Product Change Notification

(Notification – P2202008-DI)

This notification announces new part revision to improve I²C / I3C bus interface functions for select RA2E2 devices.

Appendix D: Item #1 - I²C master; Operation When Writing Transmission Data

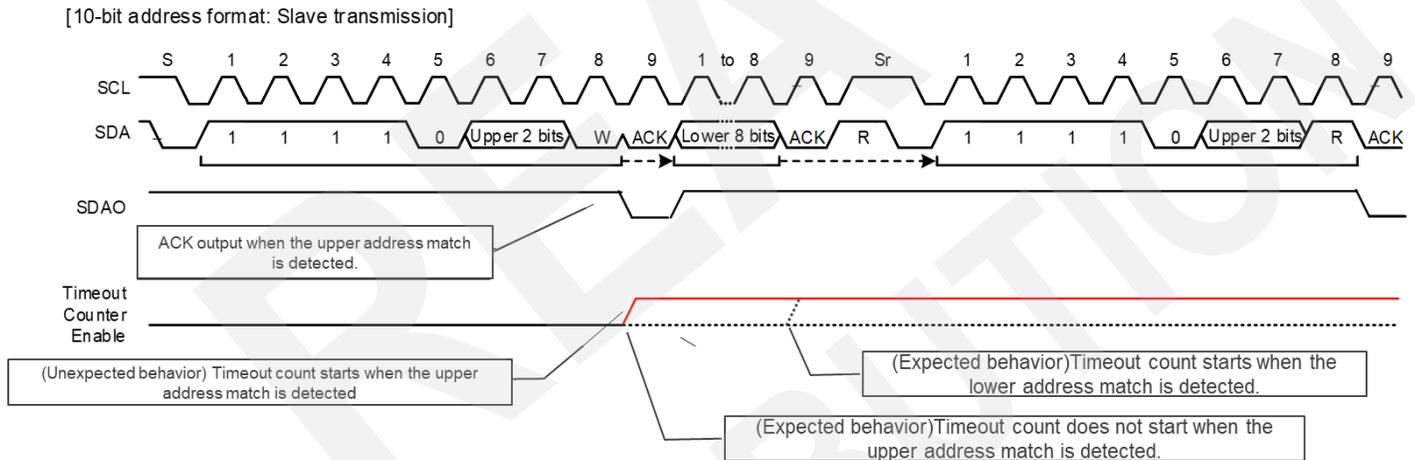
In MCU Ver.1, when the output timing of the first data of the frame and the transmission data write timing are conflicted, the transmission of the first data to be transmitted (b7) will start with a deviation of 1 bit.

MCU Ver.1 requires the software workaround when writing transmission data, but MCU Ver.2 does not require the software workaround.

Note: [MCU Ver.1 has the following restrictions and workarounds. These restrictions and workarounds are not required for MCU Ver.2.](#)

The following processing is required when checking NTST.TDBEF0 = 1 in Steps [3] and [4] of the I2C master transmission flowchart as shown in Figure 25.104.

Appendix E Item #2 - I²C slave; Timeout Count Operation When 10-bit Address Communication and the Upper Address Match is Detected

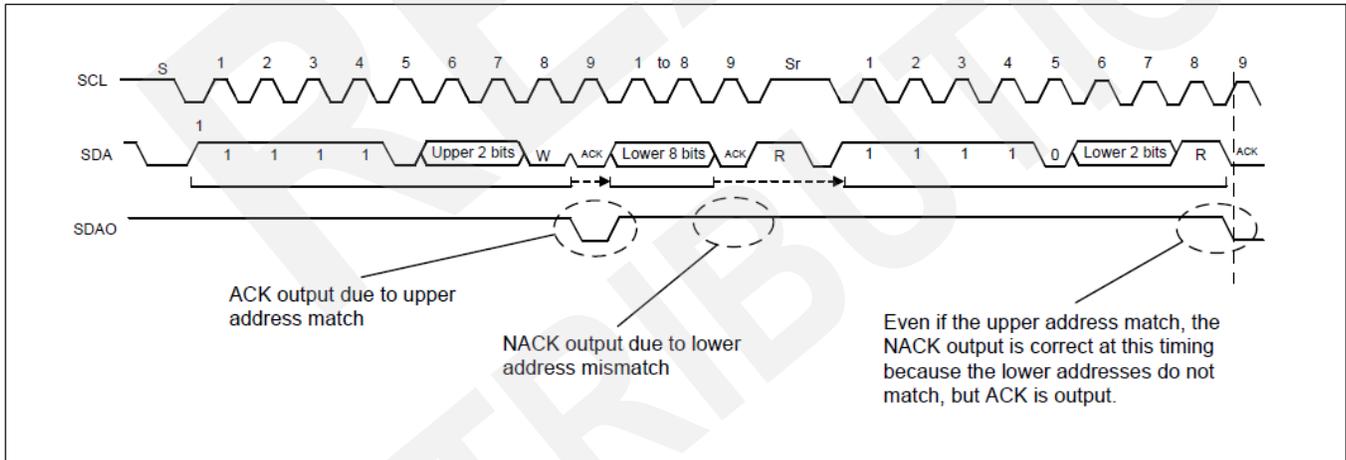
In MCU Ver.1, the timeout count starts when 10-bit address communication and the upper address match is detected.

MCU Ver.2 is revised the circuit so that the timeout count does not start until the lower address match is detected after the upper address match is detected.

Note: **MCU Ver.1 has the following restriction. The restriction is not required for MCU Ver.2.**
When working with I²C Slave, during 10-bit address communication, the timeout count starts when the upper address match is detected.

Appendix F (cont.): Item #3 - I²C Slave; ACK Output Operation When 10-bit Address Communication and the Lower Address Mismatch is Detected

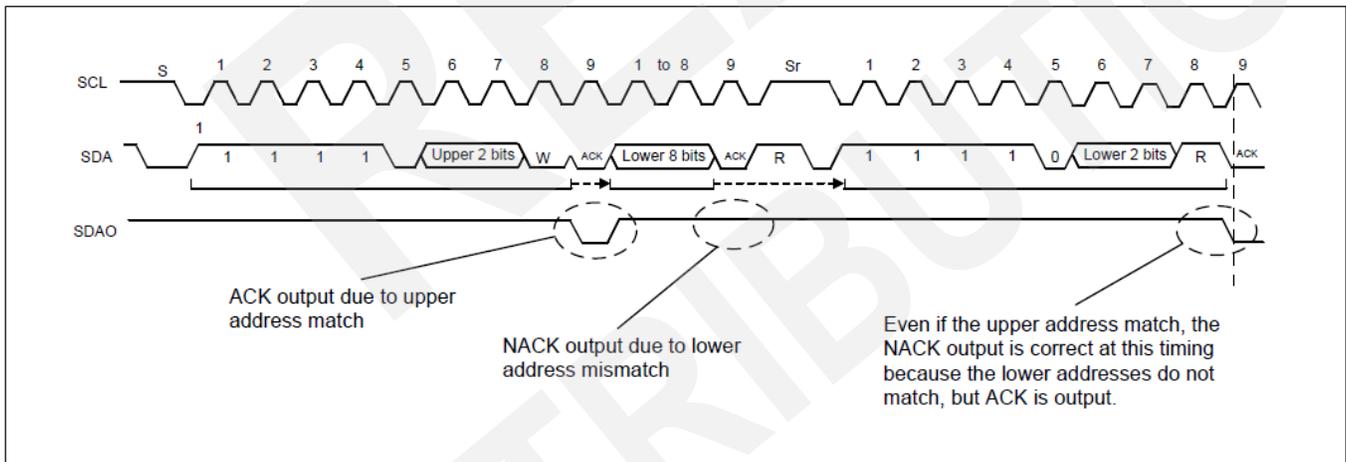
MCU Ver.1 has the following restrictions and workarounds when using 10-bit address communication.

The restrictions and workarounds are not required for MCU Ver.2

MCU Ver.1 has the following restrictions and workarounds. The restrictions and workarounds are not required for MCU Ver.2.

When multiple I²C slaves are connected to the I²C bus and there is a possibility that an I²C Slave other than this module will NACK for the upper address / R after Repeated START, there are the following restrictions and workarounds.

- Work around : Set the upper 2 bits of the 10-bit address assigned to this module to a value different from other Slave. If the address is exhausted and cannot be set to a different value, use restriction (1).
- Restriction (1) : 10-bit address not available.
- Restriction (2) : After the ACK response in the red circle in the above figure, none of the slaves respond to data, so the SDA keeps the high level and the I²C Master receives the 0xFF data. In the case of a system that can handle 0xFF as abnormal data, 0xFF is read and discarded on the I²C Master side. If 0xFF is valid data, use restriction (1).

Appendix G: Item #4 - I3C Slave; Arbitration Operation When Dynamic Address is Assigned by the ENTDAAs command

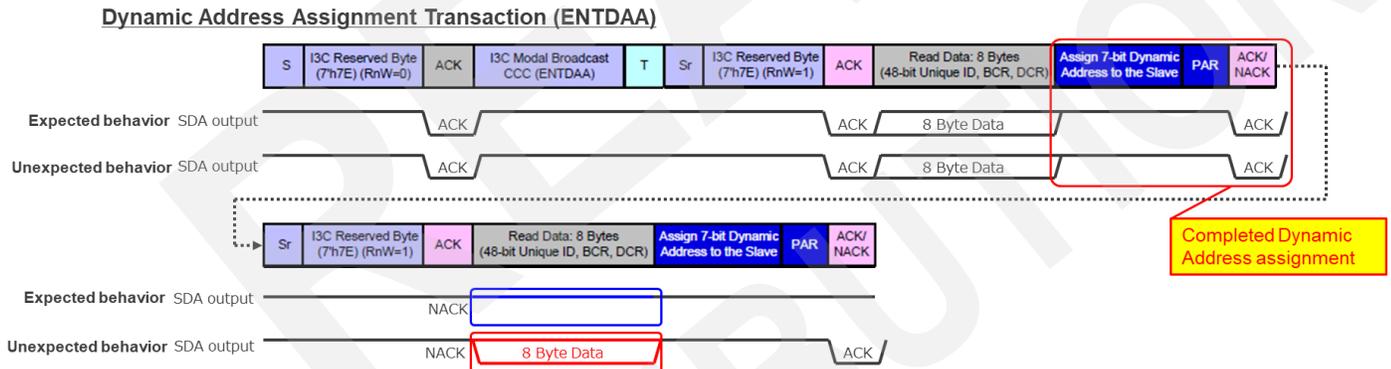
In MCU Ver.1, if a dynamic address is assigned by the ENTDAAs command in I3C slave mode, I3C will participate in dynamic address arbitration in response to the ACK response of other slaves even after the dynamic address assignment.

MCU Ver.1 requires the restrictions and workarounds when assigning dynamic address, but the restrictions and workarounds are not required for MCU Ver.2.

MCU Ver.1 has the following restriction and workaround. This restriction and workaround are not required for MCU Ver.2.

- Note: When multiple I3C (I3C Slave) are connected on the I3C Bus assign Dynamic Addresses in the following order.
1. Set the SDCTPIDH and SDCTPIDL registers (6 Bytes) of the I3C (I3C Slave) to a value (All 1 etc.) that has a lower priority than other Slave Devices by Dynamic Address Arbitration.
 2. After setting the Static Address in the I3C (I3C Slave), assign the Dynamic Address using the SETDASA /SETAASA command.
 3. Assign a Dynamic Address to an I3C Slave Device other than the I3C (I3C Slave) using the ENTDAAs command.

Figure 25.96 Example of error recovery operation flowchart for I3C Master

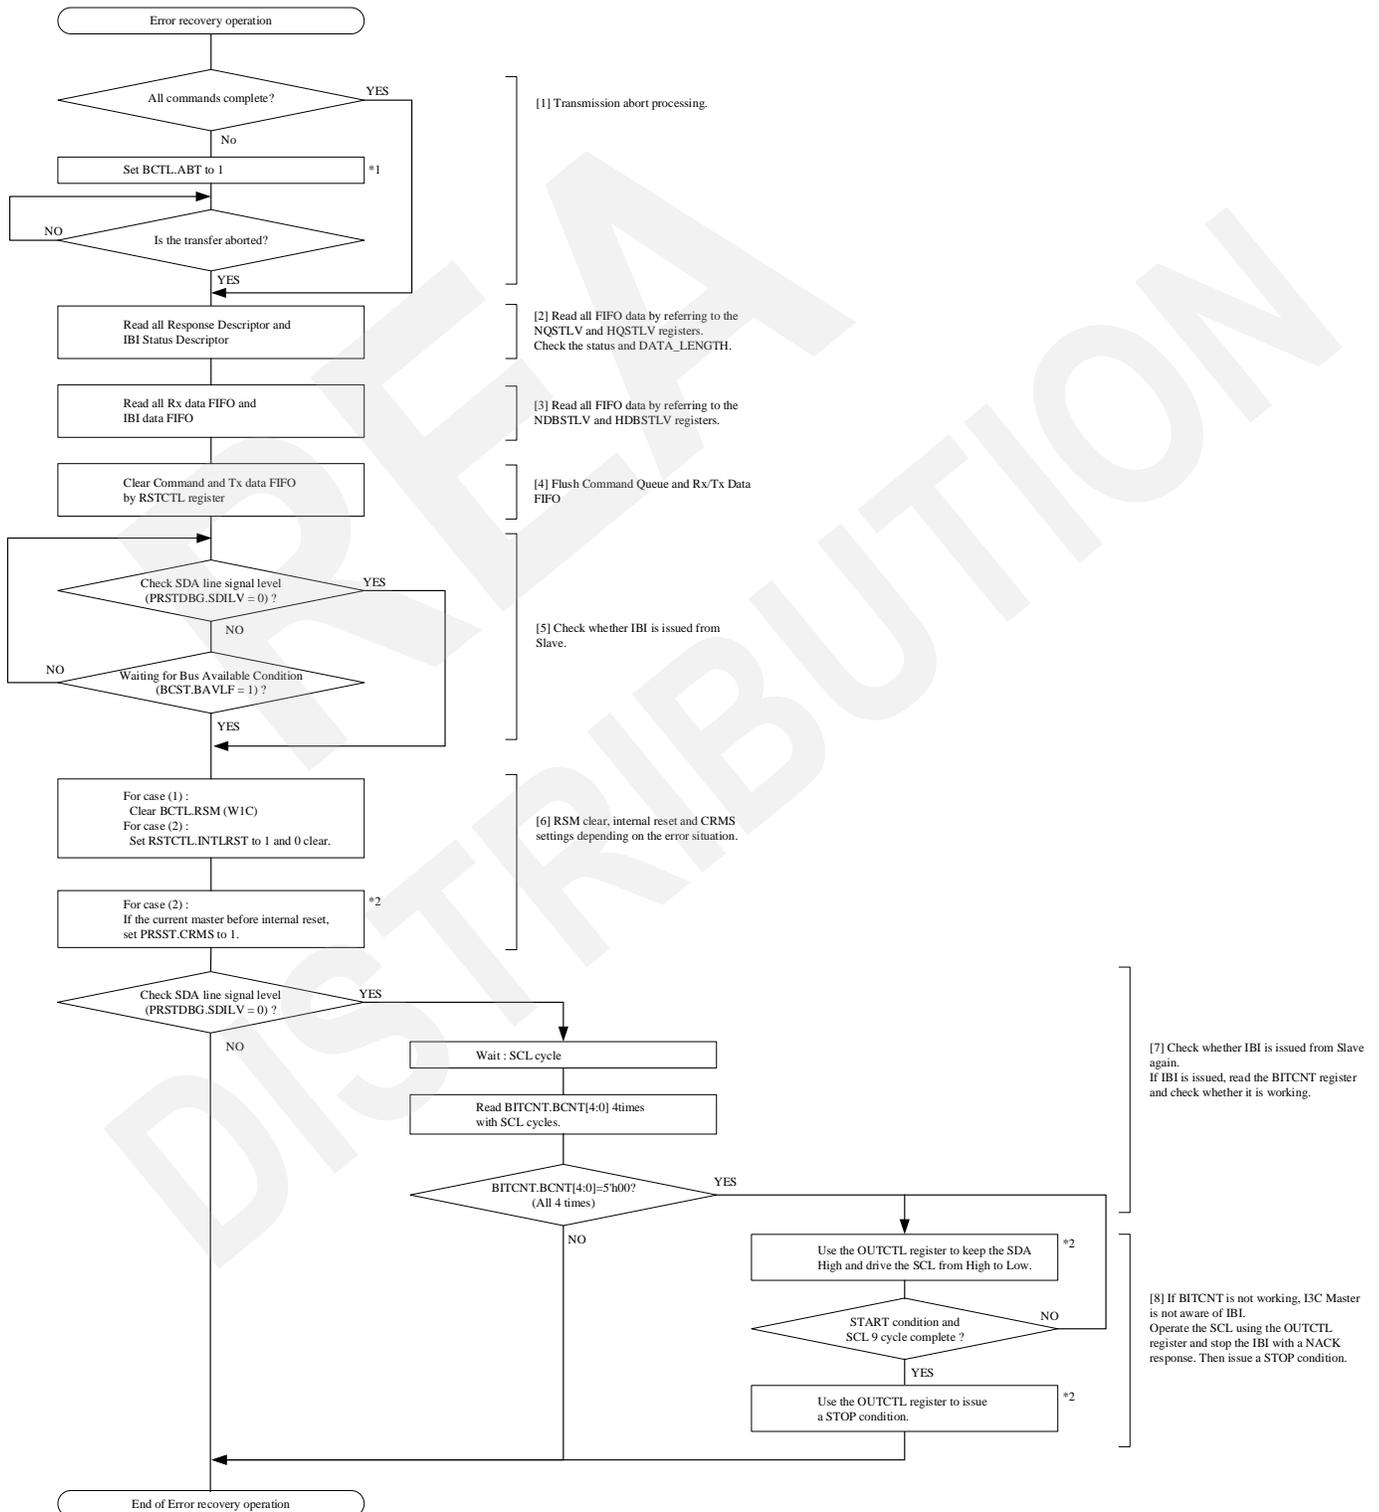
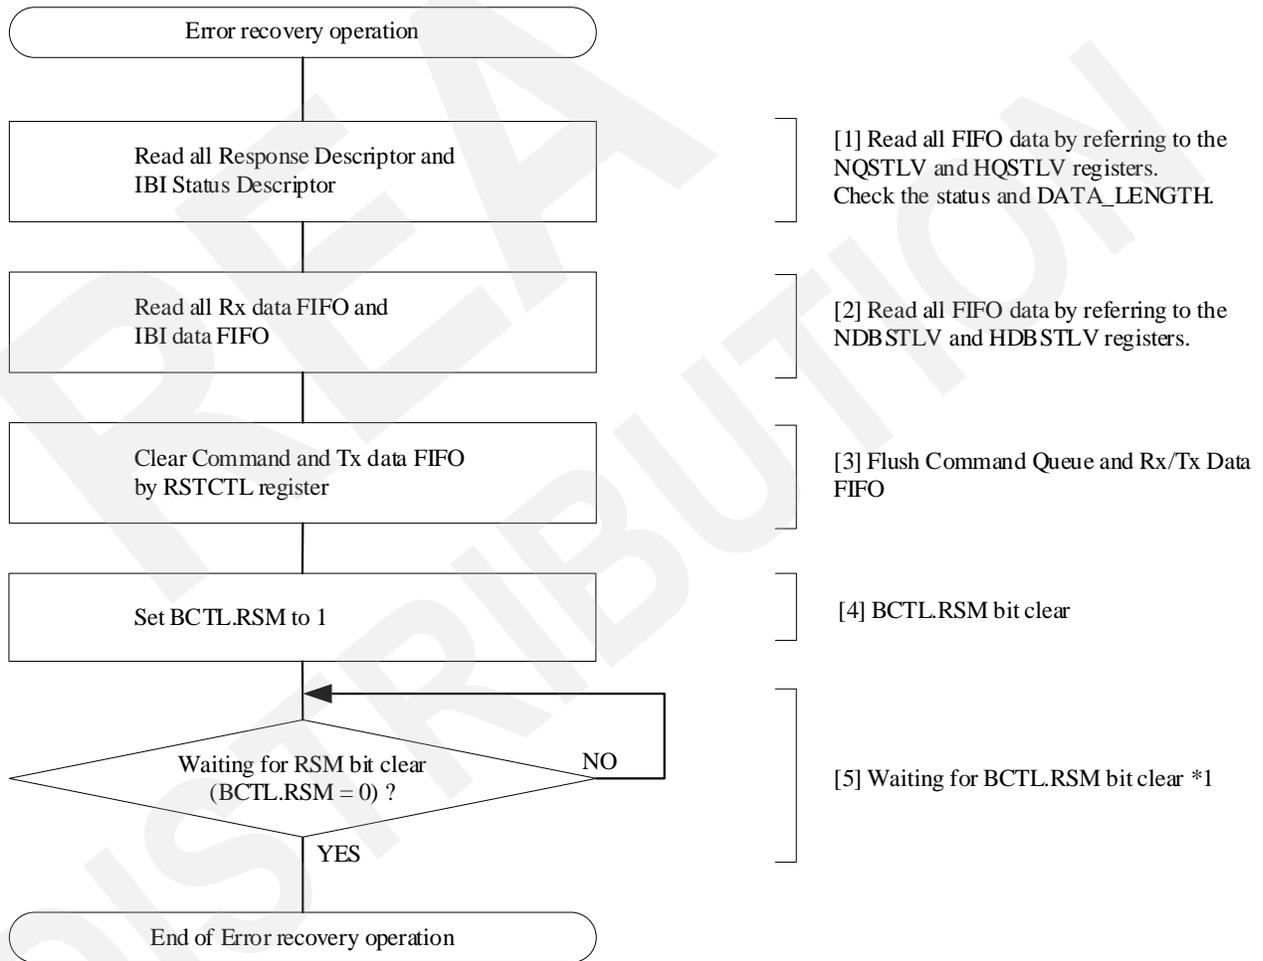
In order to improve the complexity of the error recovery flow, MCU Ver.2 is revised the circuit so that I3C will be suspended (BCTL.RSM becomes 1) when an error occurs. After I3C is suspended, the application must write the value 1 to the BCTL.RSM bit to resume I3C operation and recover form suspended state.

In MCU Ver.2, the error recovery flow shown in Figures 25.96 and Figures 25.97 are simplified by the above improvements.

Figure 25.96-1 and Figure 25.97-1 show the error recovery flow of MCU Ver.1.

Note: For MCU Ver.2, apply the following error recovery flow.

If an error occurs, I3C will be suspended. (BCTL.RSM becomes 1.) After I3C is suspended, the application must write the value 1 to the BCTL.RSM bit to resume I3C operation and recover from the suspended state.
